PROJECT *(Name and Address)*
EAST HEIGHTS ELEMENTARY SCHOOL RENOVATION
1776 ADAMS LANE
HENDERSON, KY 42420

CHANGE ORDER NUMBER: 14-1
INITIATION DATE: 6/11/2025

Re: PR-01– Electrical Panelboards
Henderson Co. East Heights Elementary School
CMTA Project No. XHER23

Contract Change Requested By Architect/Engineer
Contract Change Reason Code Reduction of Scope
Change Order Description And Justification
Various distrbution and panelboard changes.

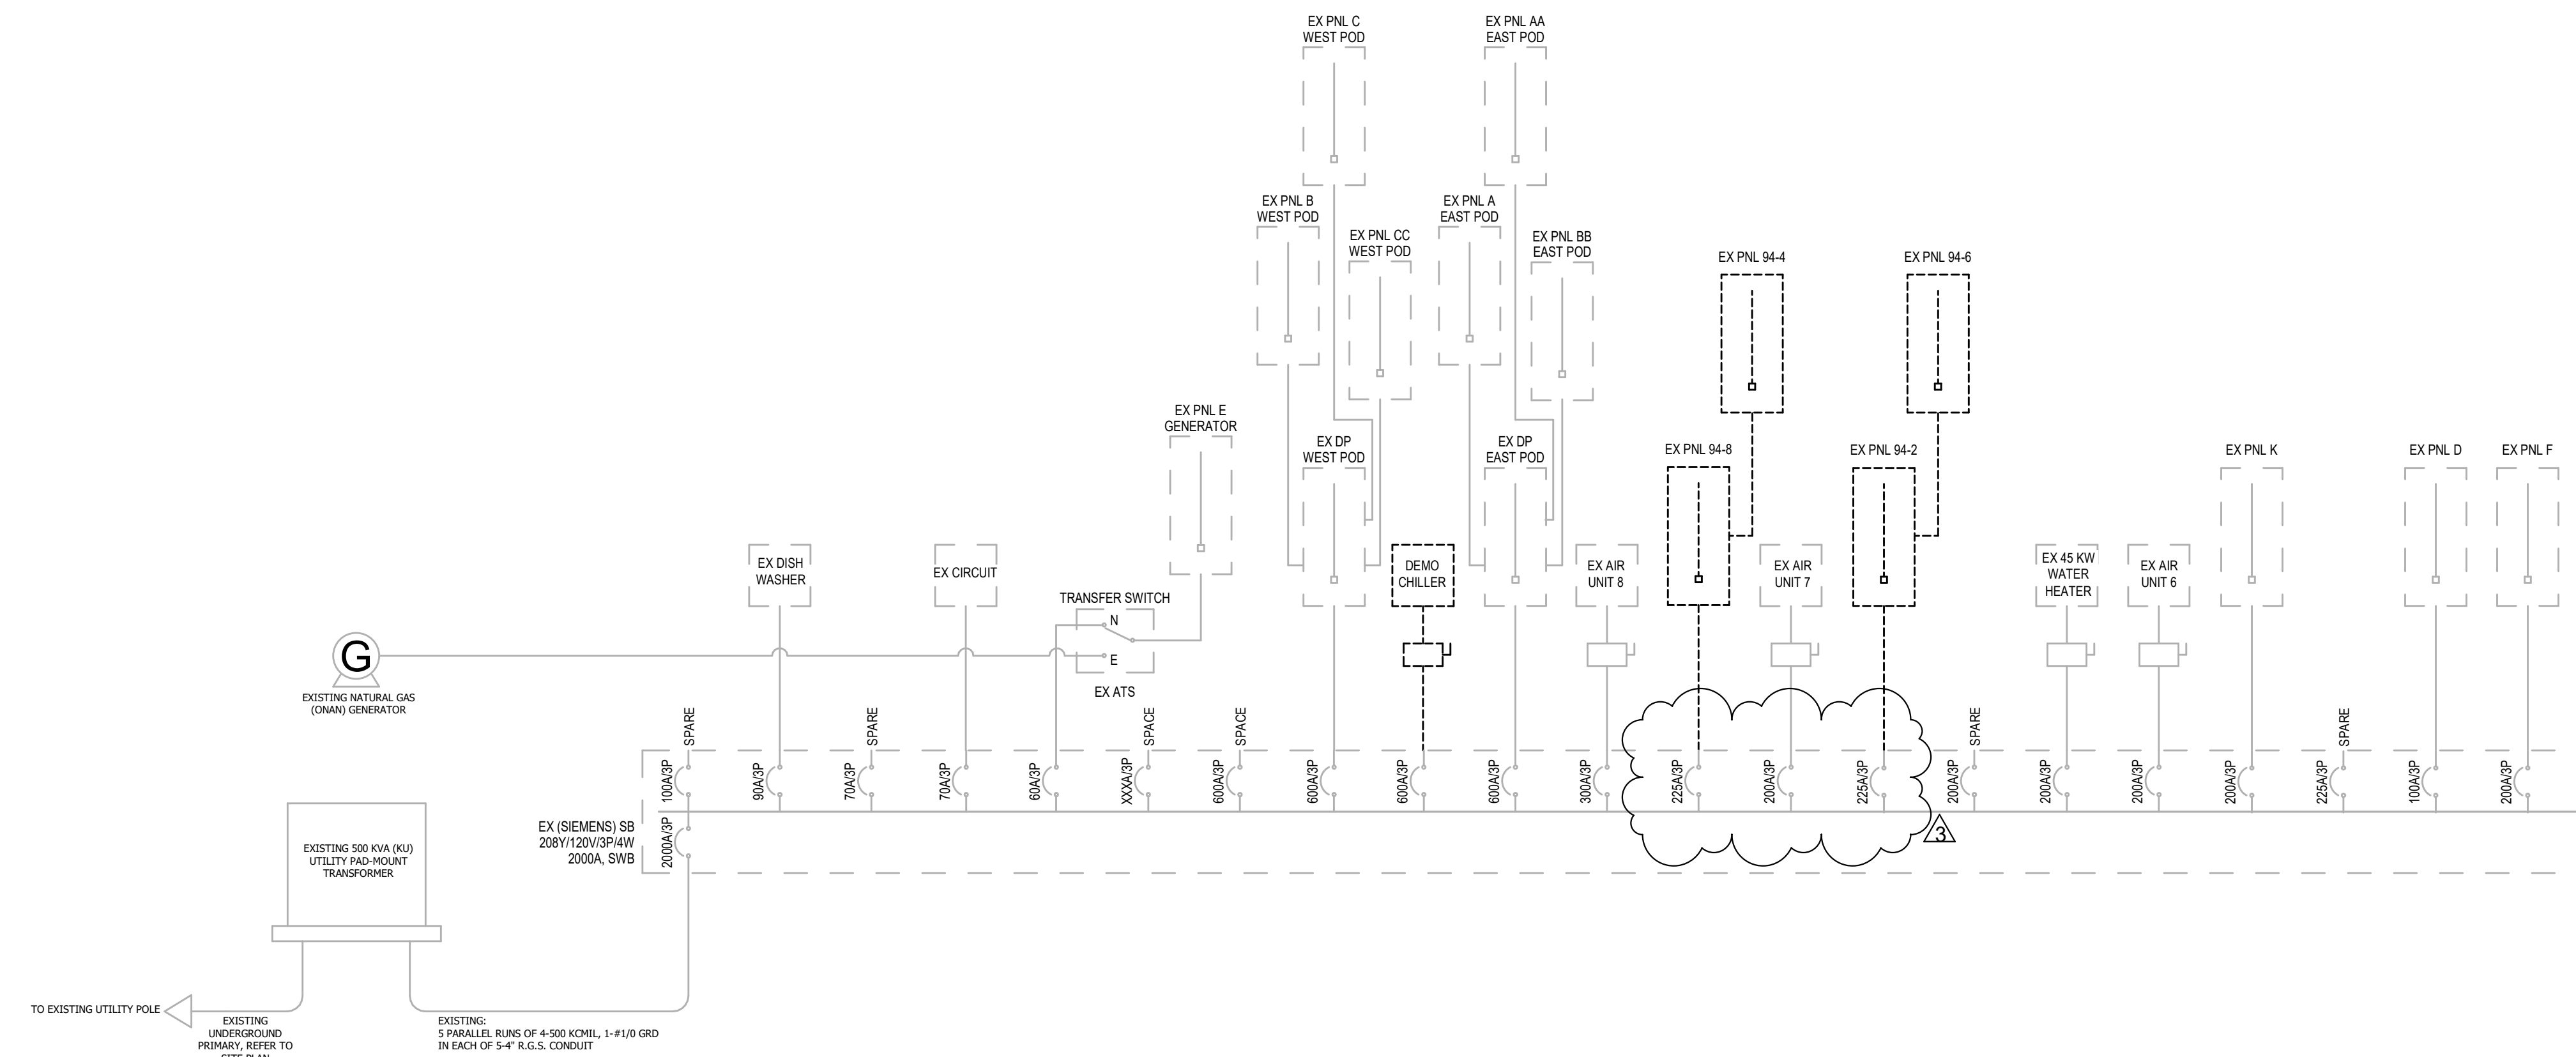
1. Refer to Sheet E0.30 – PANEL SCHEDULES:
 - a. Refer to clouded region. Provide 225A panel for PP3 instead of 100A.
 - b. Refer to clouded region. Provide 60A/3P breaker at PP3 panel for LP3 instead of 100A/3P breaker. Refer to clouded changes on One-line diagram for updated wire size and conduit: 4-#6, 1-#10 instead of 4-#3, 1-#8.

- c. Refer to clouded region. PP5 panel shall be MLO instead of MCB.
2. Refer to Sheet E0.31 – PANEL SCHEDULES:
 - a. Refer to clouded region. MP1 panel shall be MLO instead of MCB.

- b. Refer to clouded region. DP4 distribution panel shall be MLO instead of MCB.
 - c. Refer to clouded region. ELS1 panel shall be 225A MCB instead of 100A MLO. Provide 60A/3P breaker at ELS1 panel for ELS1B instead of 100A/3P breaker. Refer to general note shown on this panel schedule. Refer to clouded changes on One-line diagram for updated wire size and conduit.

- d. Refer to clouded region. ESB1 panel shall be 225A MCB instead of 225A MLO. Refer to general note shown on this panel schedule.
 - i. Refer to One-line diagram and clouded region on Sheet E3.78: Omit SBATS2 transfer switch to panel ESB2. ESB2 panel shall be fed from ESB1 panel and be provided with 60A/3P breaker at ESB1. Refer to One-line diagram for wire size and conduit.

1. ESB2 panel shall be 100A MLO instead of 225A MCB.
 - ii. Refer to One-line diagram: Refer to updated wire size and conduit for panel ESB1B.
3. Refer to Sheet E2.78 – ELECTRICAL ONE-LINE DIAGRAM DEMOLITION – PHASE 2

E2.78

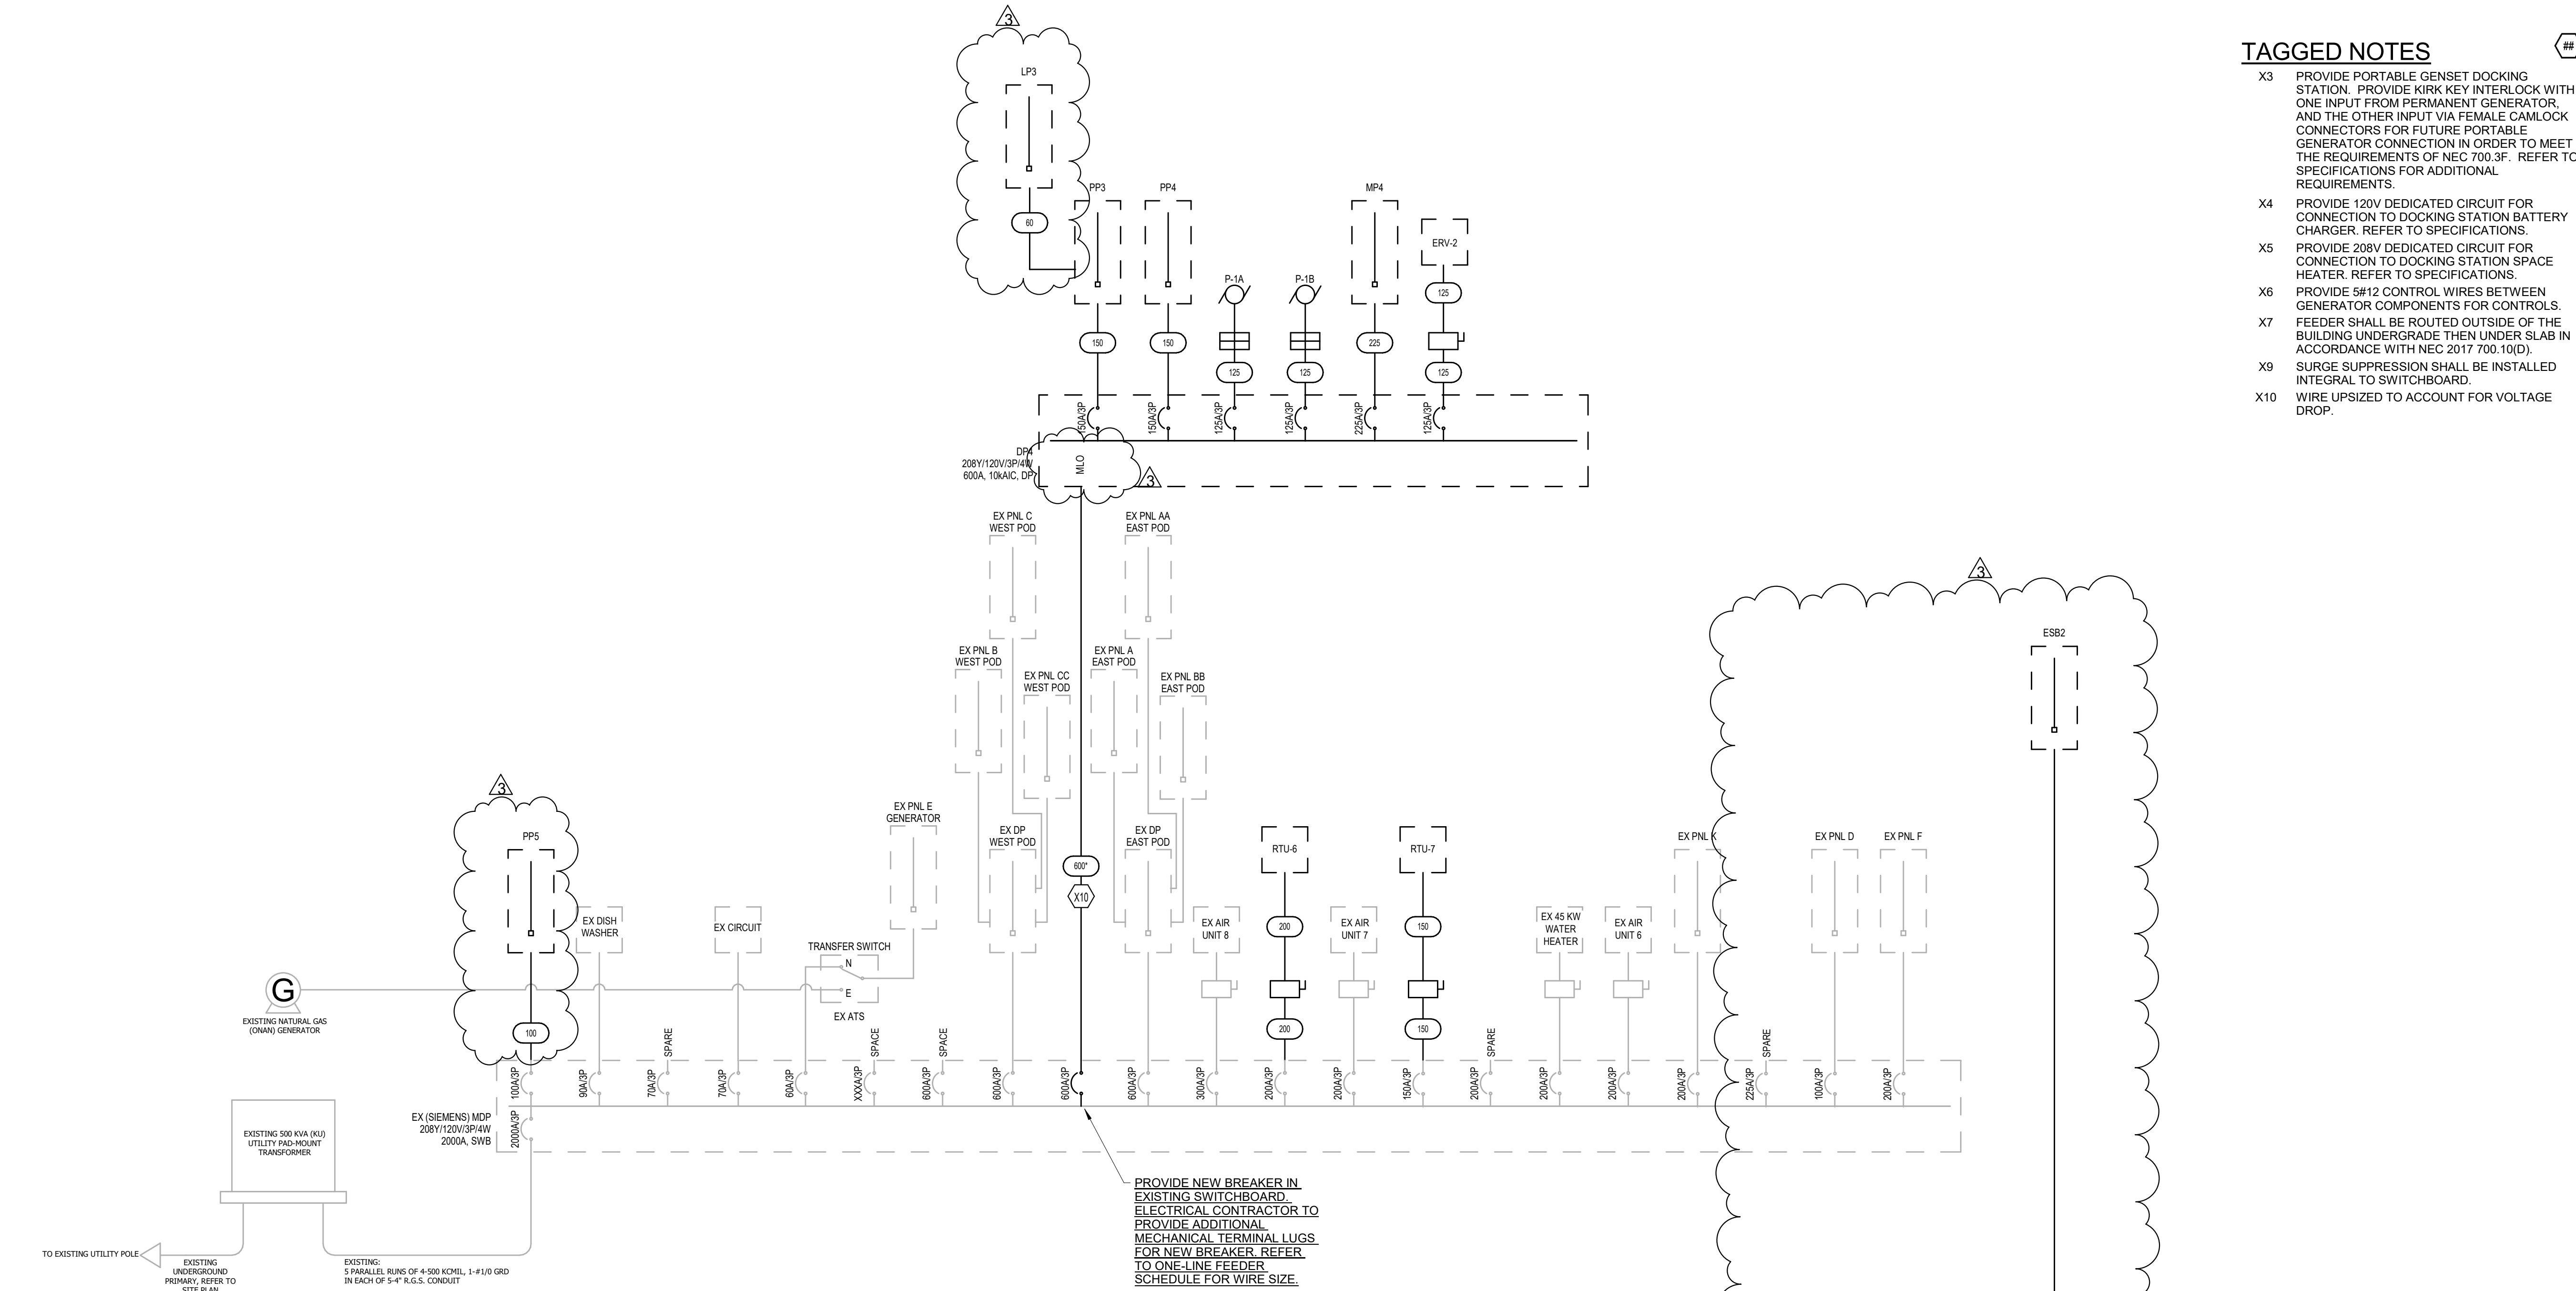
- a. Refer to clouded region for correction.
4. Refer to Sheet E2.88 – NEW ELECTRICAL ONE-LINE DIAGRAM – PHASE 2
 - a. Refer to clouded regions for changes:

NEW GEAR ONE-LINE DIAGRAM - PHASE 2

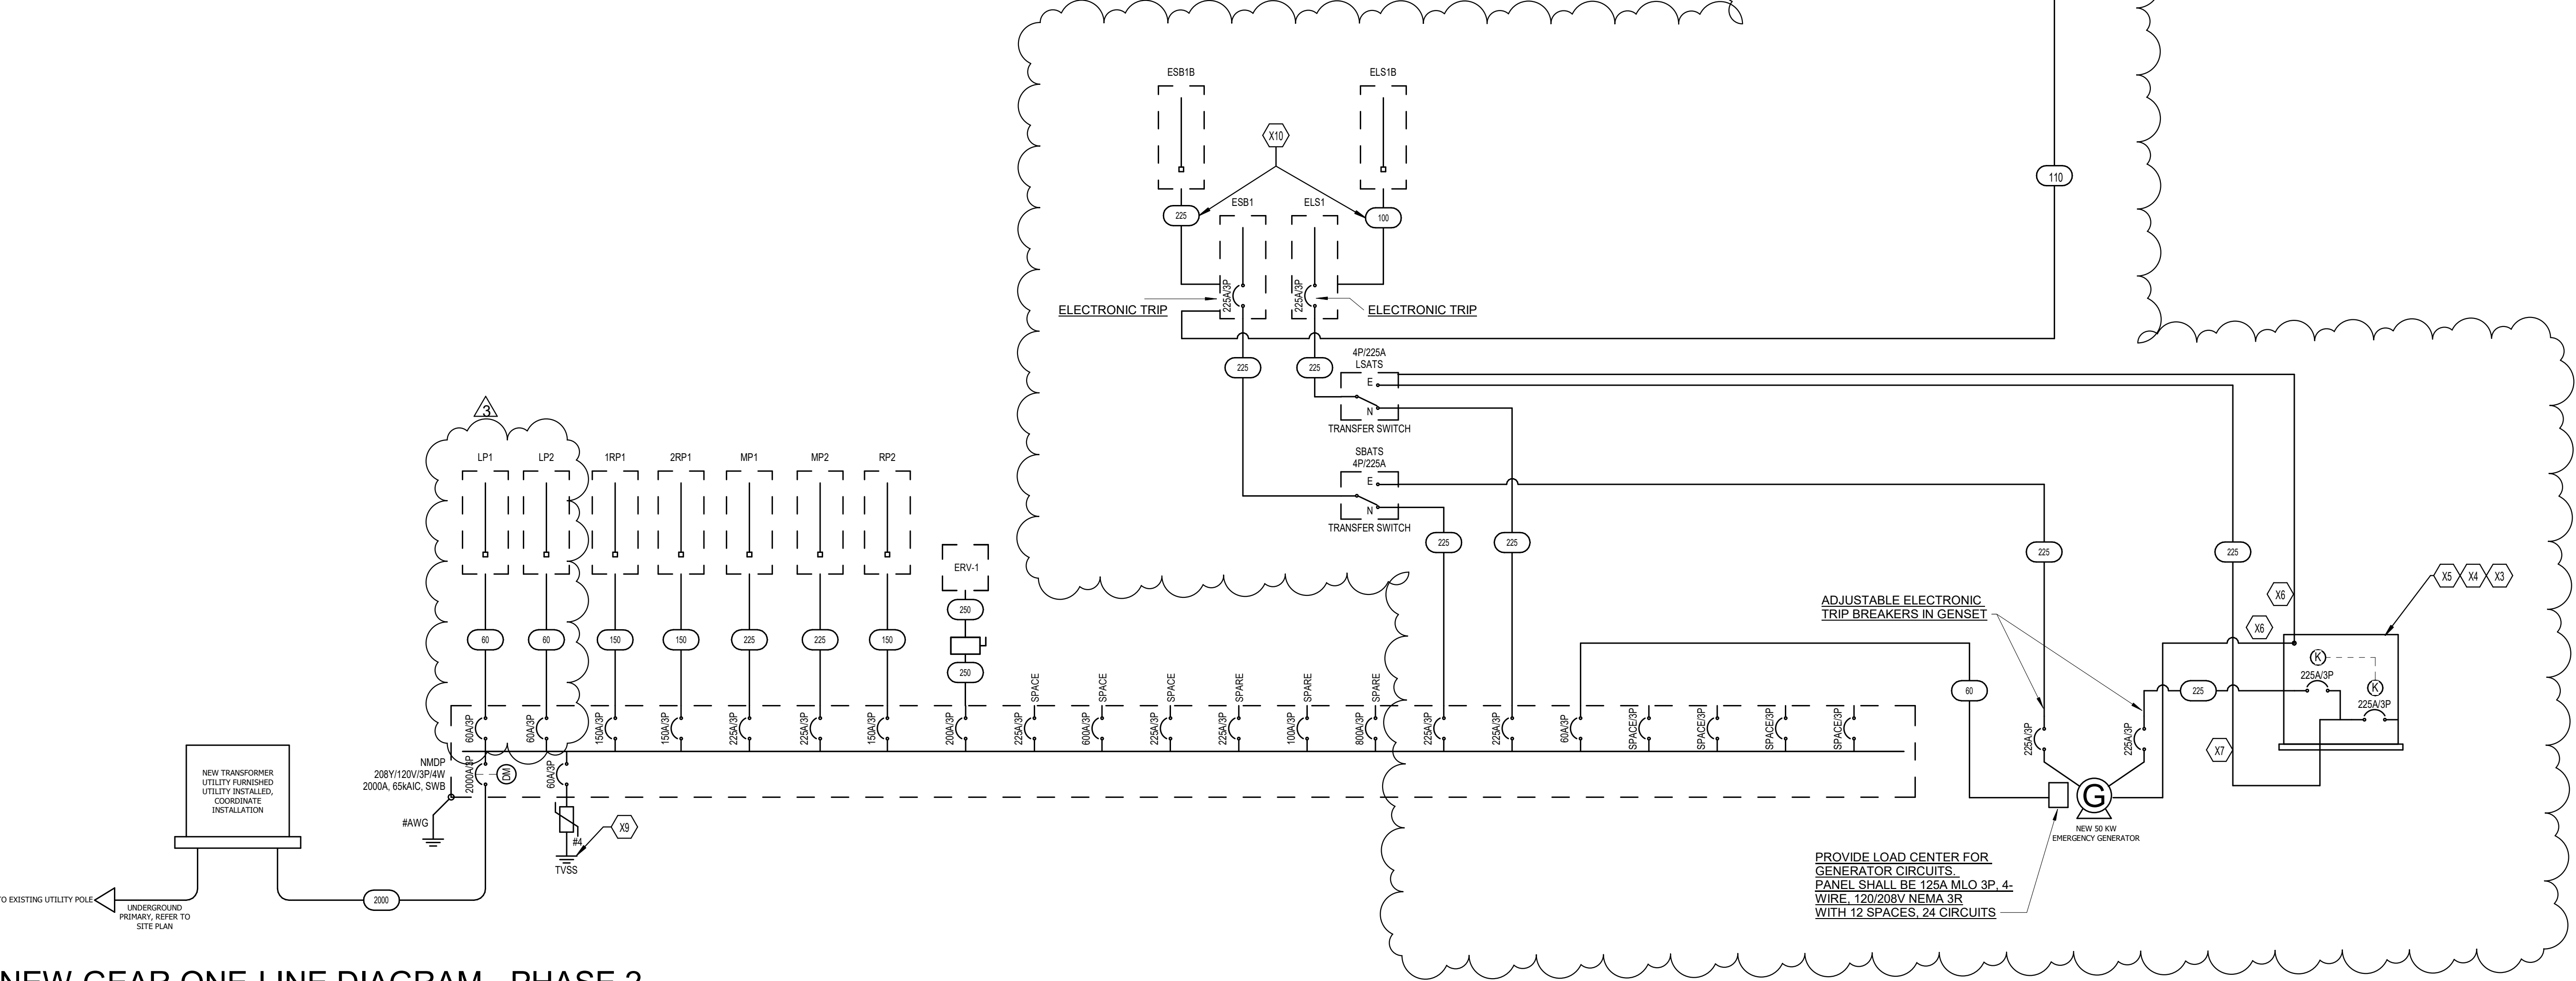
- i. Provide 60A/3P at the new NMDP for both LP1 and LP2 instead of 100A/3P. Refer to change/decrease in wire size as well.
 - ii. Provide DP4 with MLO instead of MCB.

- iii. PP5 is now shown as being fed from EX (SIEMENS) MDP. Utilize existing 100A/3P spare breaker at the panel.
- iv. LP3 shown with change/decrease in wire size.

- v. Per Item #2(d)(i): ESB2 panel fed from ESB1 panel.
- b. For Generator panels:
 - i. General note: Refer to changes in wire sizes.
 - ii. Provide two (2) 225A/3P electronic trip breakers on the generator instead of four(4) 100A/3P breakers on the generator: One for ELS1 branch and the other for ESB1 branch.

- iii. Docking Station shall be 225A/3P instead of 100A/3P.
 - iv. LSATS transfer switch shall be 225A/4P instead of 100A/4P.
 - v. SBATS transfer switch shall be 225A/4P instead of 100A/4P.

- vi. Refer to additional information for the provision of dedicated load center for generator circuits (battery charger, heater, etc.).
- 5. Refer to Sheet E3.11 – ELECTRICAL DEMOLITION PLAN – PHASE 3 – AREA B
